Responses to CEC Data Requests: Nos. A1 through A123

Amended Application for Certification for HYDROGEN ENERGY CALIFORNIA (08-AFC-8A) Kern County, California

**RESPONSES TO DATA REQUESTS A1 THROUGH A123
FROM CALIFORNIA ENERGY COMMISSION (CEC)**

FIGURE A89-1

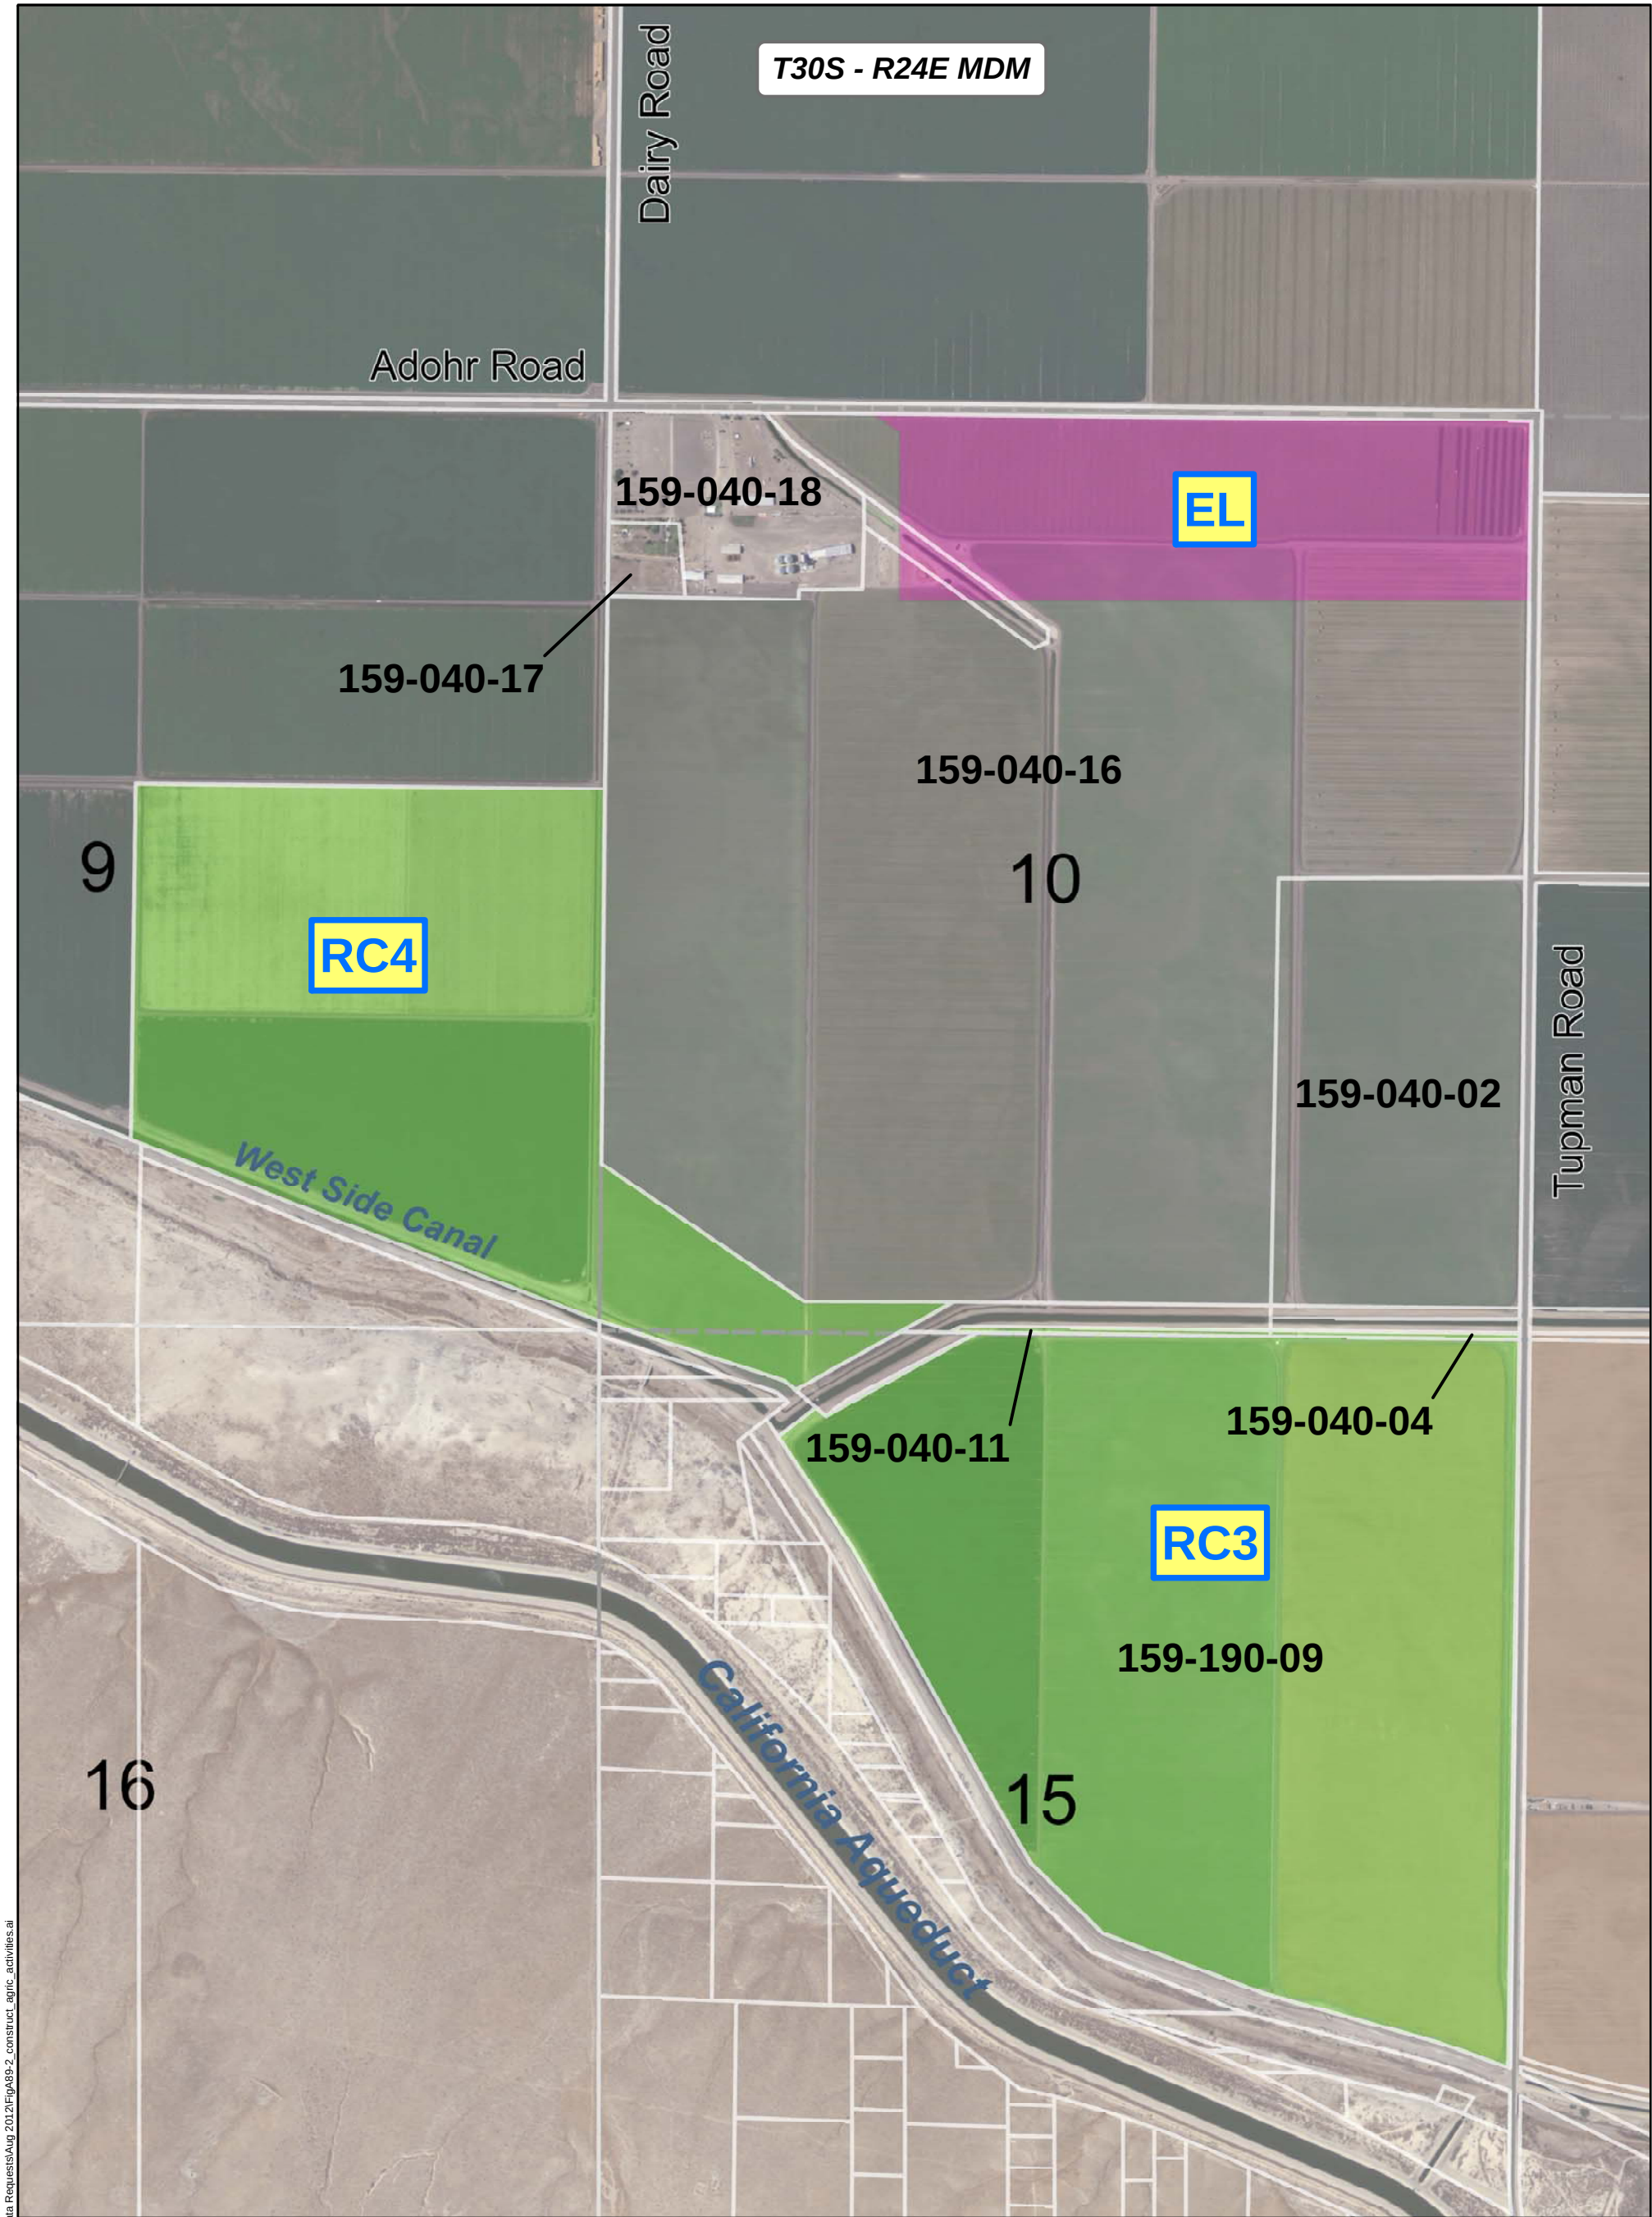
- a. The types, locations, and frequencies of agricultural activities currently undertaken in the controlled area.**
- b. The depth of ground disturbances described in item a above.**
- c. The types, locations, and frequencies of agricultural activities proposed during construction and operation of the proposed project.**
- d. The parties responsible for implementing the activities described in item c above, insofar as they are known.**
- e. The depth of ground disturbances described in item c above.**
- f. Maps at 7.5-minute (1:24,000) scale on U.S. Geological Survey topographic maps or aerial photographs (scale of 1 inch = 200–600 feet) that depict the location of current and proposed ground-disturbing activities in the controlled area.**
- g. Sources of information (documents, personal communication with landowner or tenant, etc.) and the dates on which the information was acquired.**

- a. Row crops are currently grown on the property in areas RC1, RC2, RC3 and RC4 (see Figure A89-1). The types of row crops that are grown today are cotton and alfalfa. In the past, cotton, alfalfa, wheat, sugar beets, and onions have been grown. Area ESM is used for equipment storage and maintenance. Area RH is currently residential housing.
- b. Areas RC1, RC2, RC3 and RC4 are periodically “ripped” to a depth of 30 inches (every 2 to 4 years depending on the crop.) Prior to 1990, the same areas were “ripped” to 36 to 42 inches.
- c. Agriculture activities proposed during construction are presented in Figure A89-2. Agricultural activities and the growing of row crops will continue in areas RC3 and RC4

FIGURE A102-1
(REVISED FIGURE 2-4)

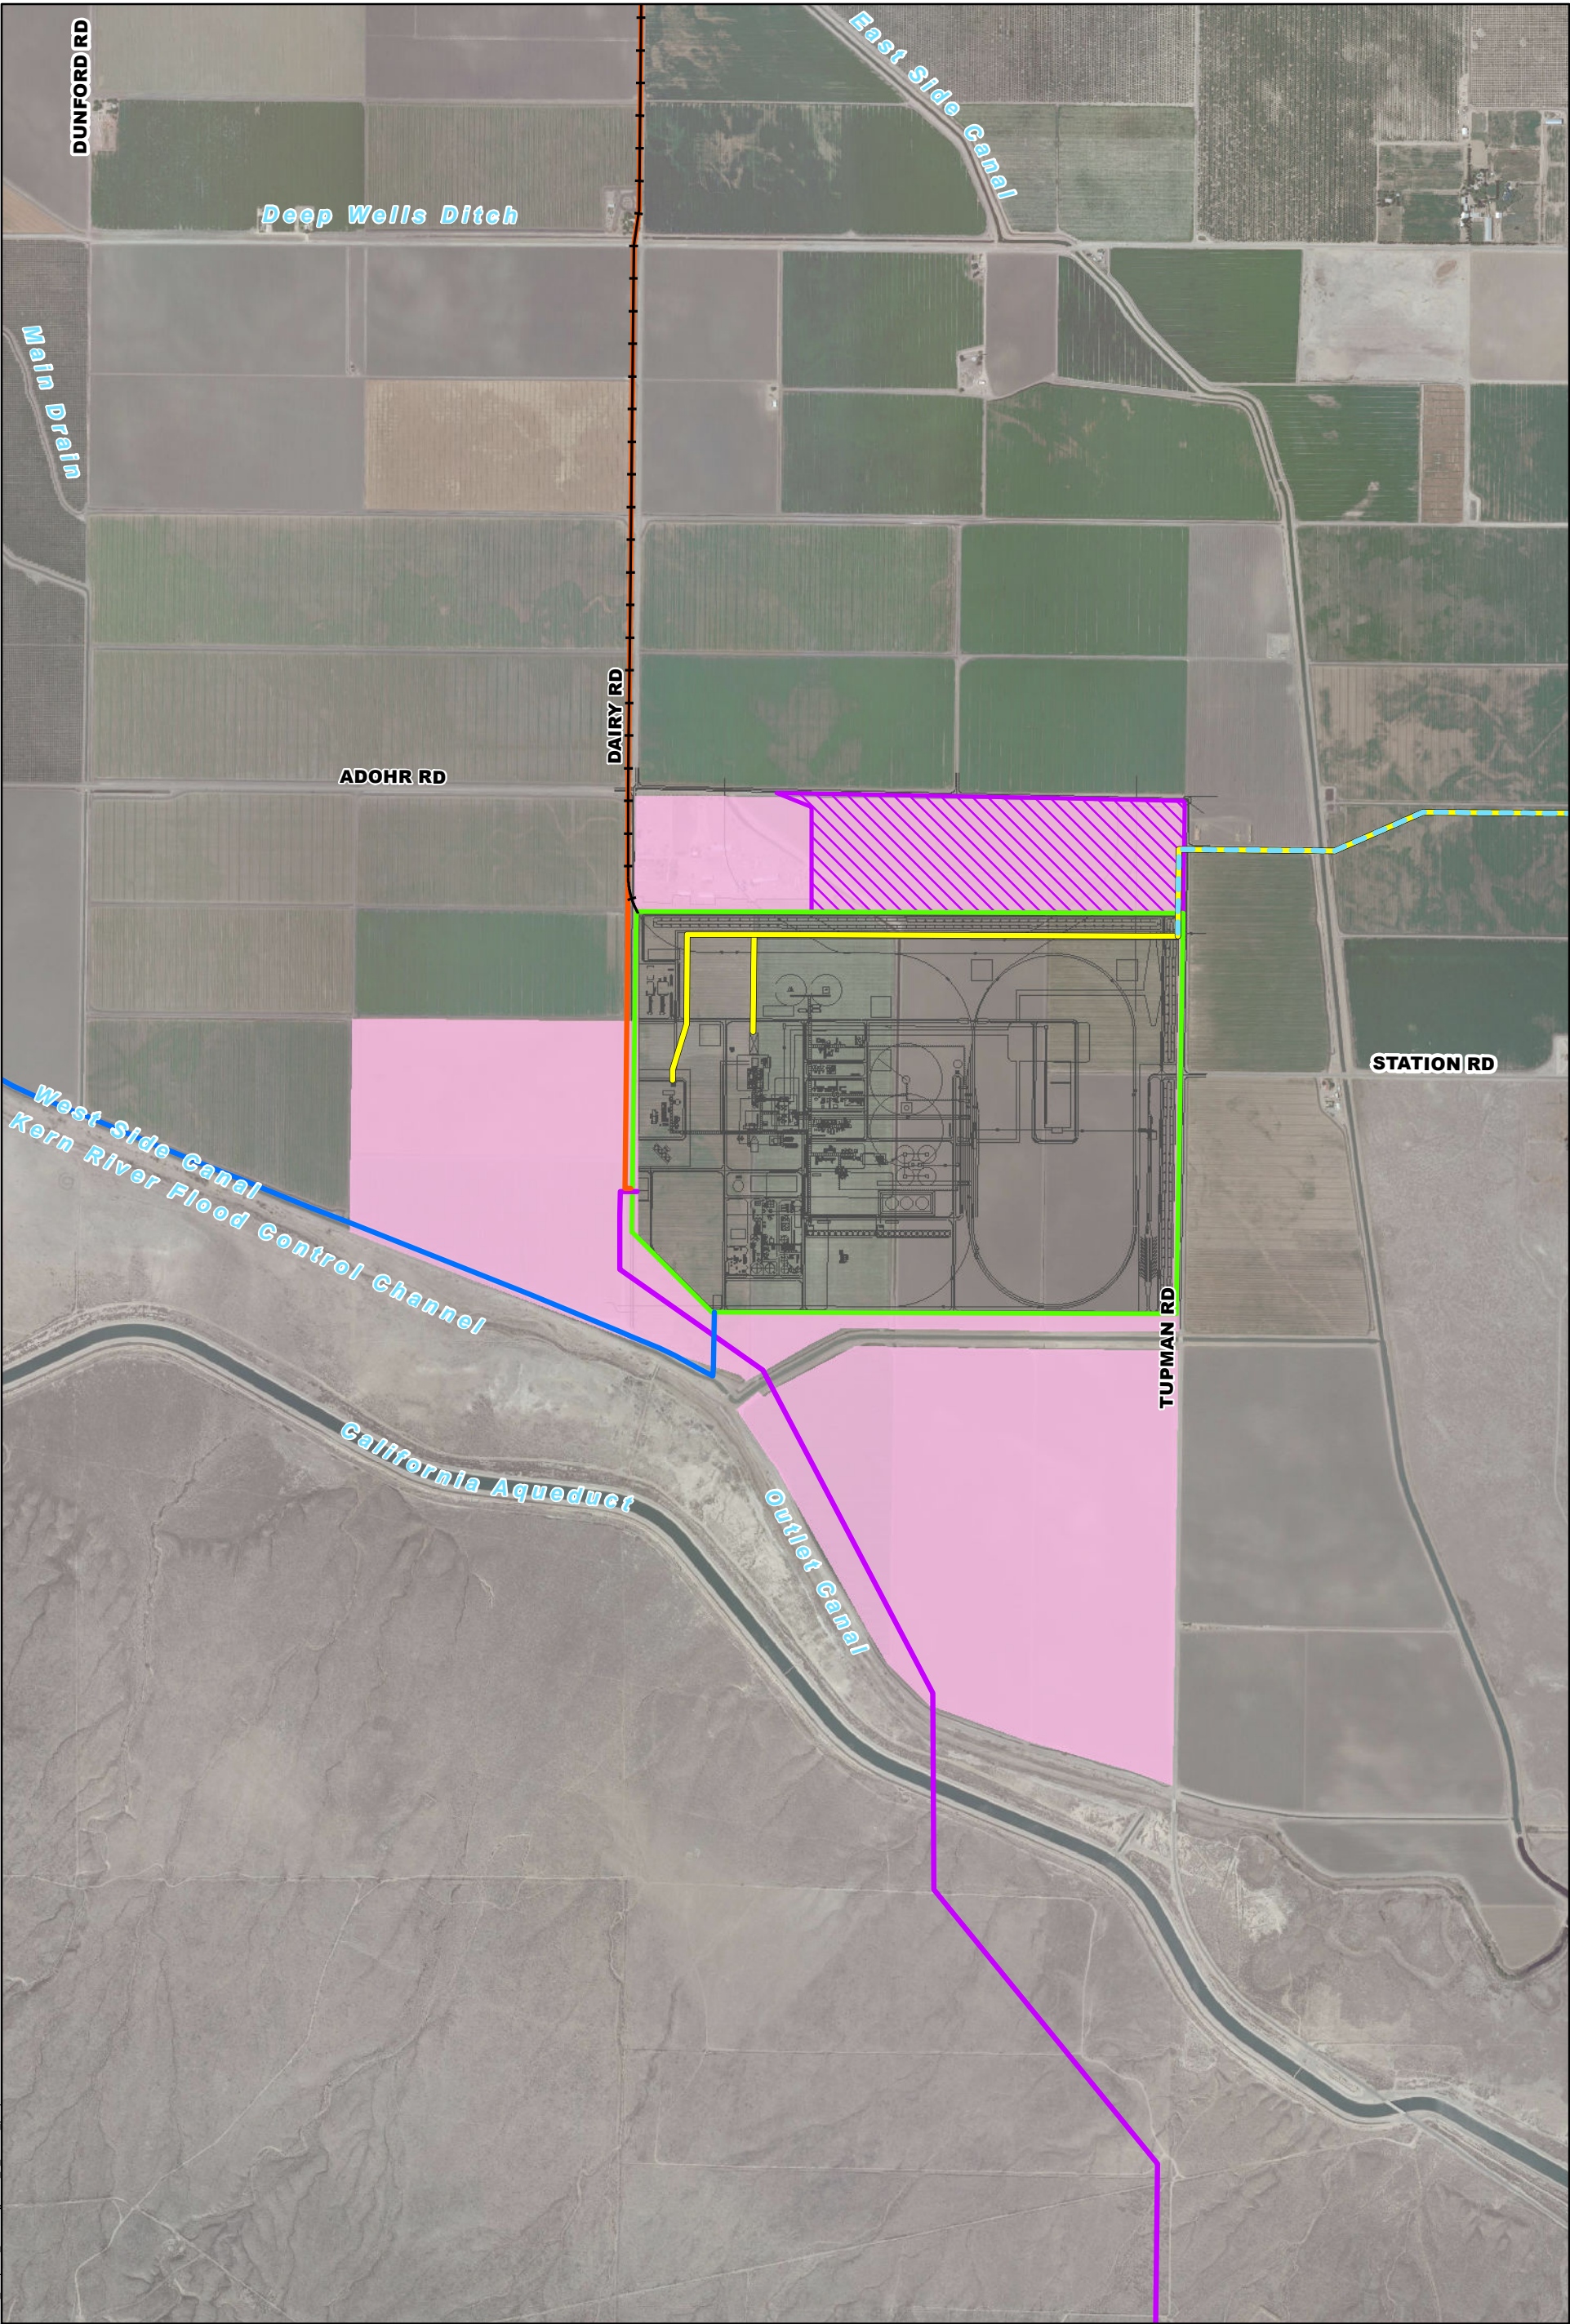
A102. Please explain how the controlled area will be used and discuss in detail any planned or anticipated activities on or uses of the area that may occur during the life of the project.

As depicted on Figure A102-1 (Revised Figure 2-4) Site Plan, the Controlled Area consists of 653 acres located adjacent to the Project Site. The Applicant currently has an option to purchase this land, and will become the landowner.
